Interconnection Facilities Study Report GI-2014-4

60 MW Wind Generation Facility Expansion Interconnecting at Spring
Canyon in Logan County, Colorado

PSCo Transmission Planning
July 10, 2014

Customer Proposed Revised Diagram of the GI-2014-4 Interconnection at Spring Canyon 230 kV with New Metering Locations

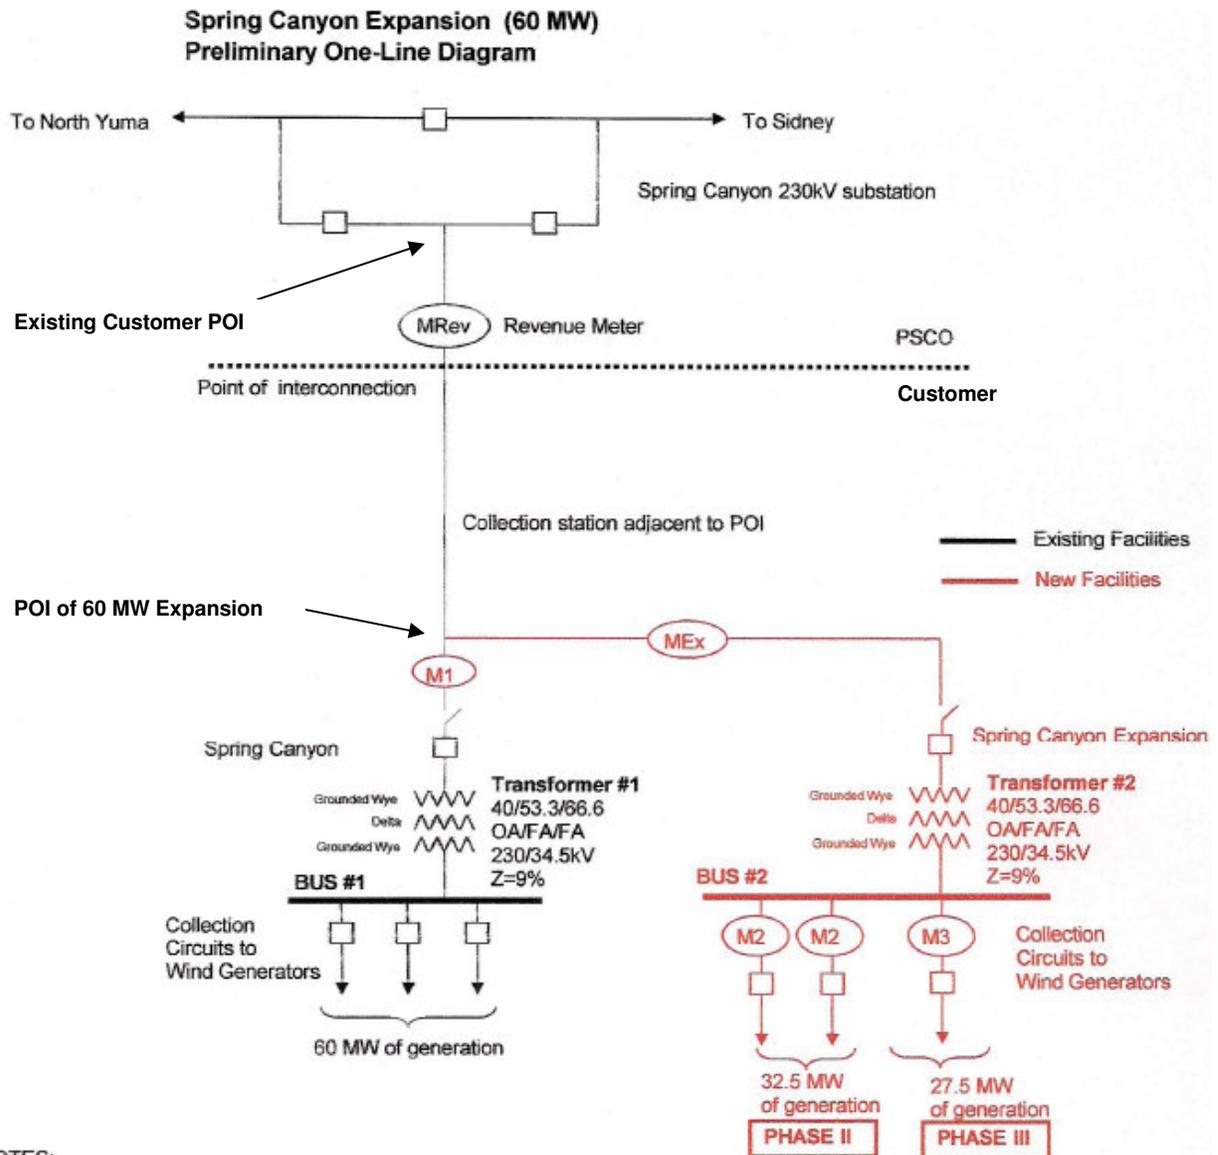
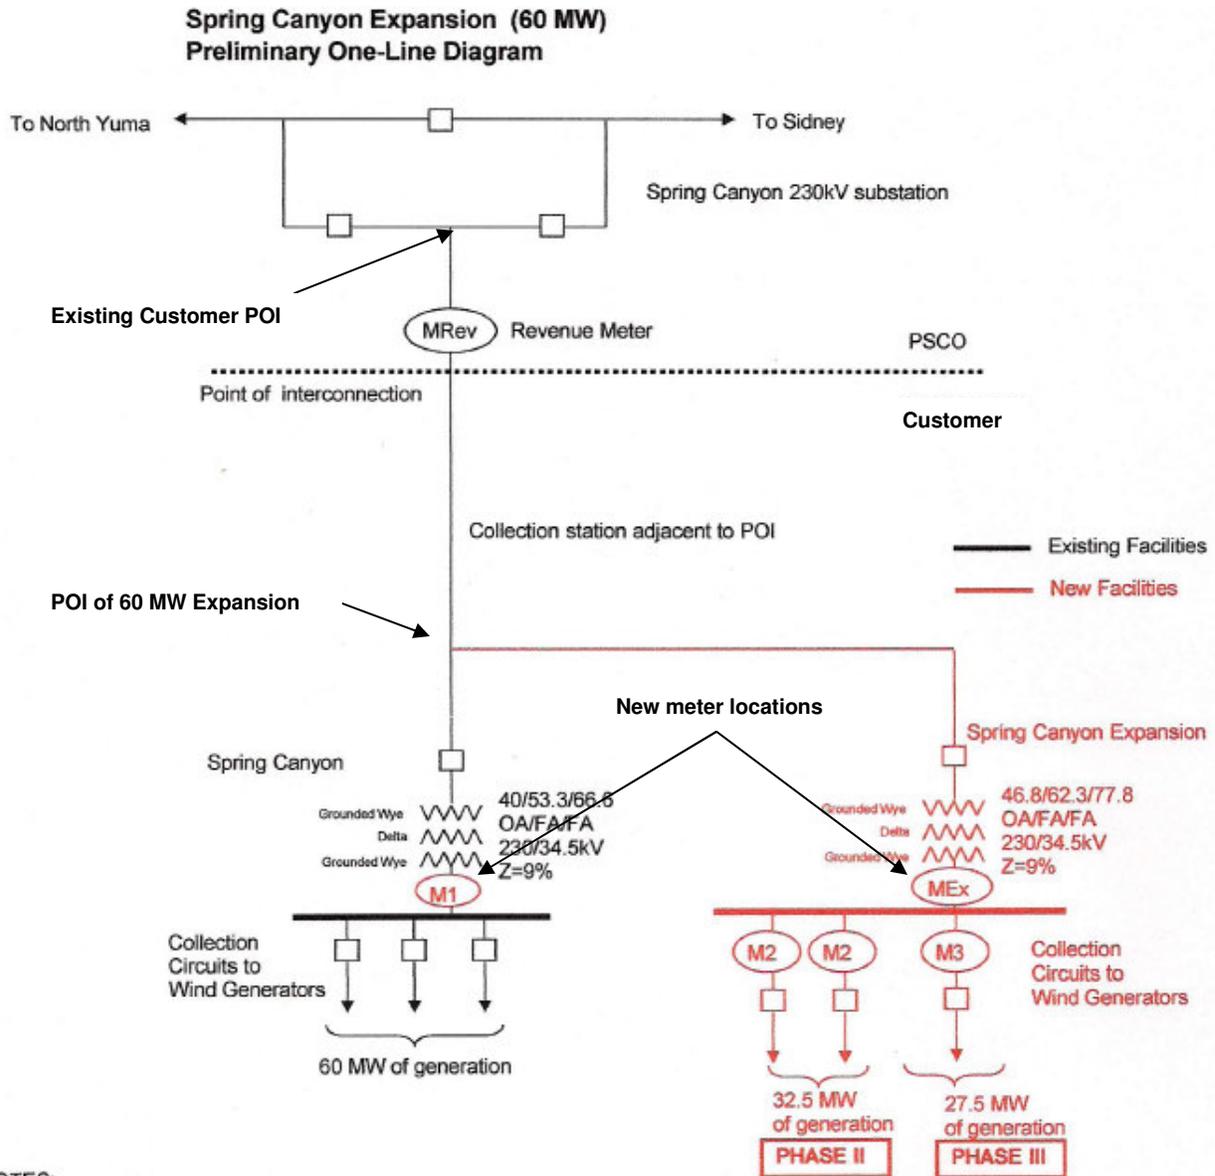
3. The Customer has requested that Figure 1 on page 3 be updated to show a new location of meters M1 and MEx from the line side of the generator step-up transformers to the generation side.

- a. PSCo recommends that meters M1 and MEx remain on the line side of the generator step-up transformers in order to capture the transformer losses between the generation facilities and the revenue meter. Additionally, PSCo recommends that a way to determine retail load service behind the revenue meter is accounted for in the LGIA.

- b. The Customers proposed revised diagram with the new metering locations can be seen below.
